HASLEMERE TOWN COUNCIL

Town Meadow Playground Design and Fencing

Playground Layout

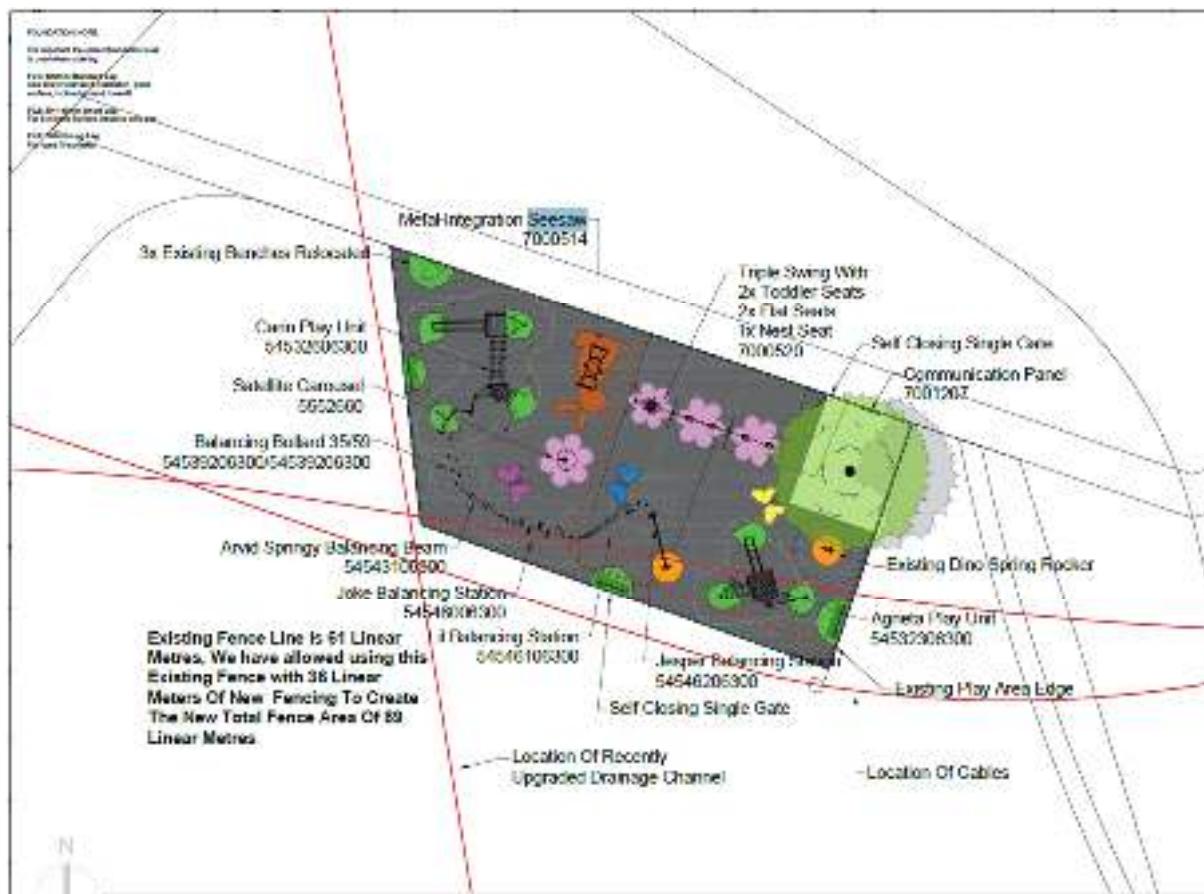
Eibe has been provided with utility plans for the area. The current proposal for an expanded square-shaped playground is not feasible due to the presence of a large drainage hole. The revised proposal is to elongate the playground along the path towards Tanners Lane and angle it as shown in the attached plans.

1. It is proposed that both gates open onto the path, rather than one onto the meadow, as originally planned. There is no path to the meadow gate, so the CAD drawing should be updated accordingly.
2. Eibe will reposition the original entrance away from the tree to prevent mud being tracked onto the new wetpour surface. The existing woodchip can be reused around the tree roots for protection.
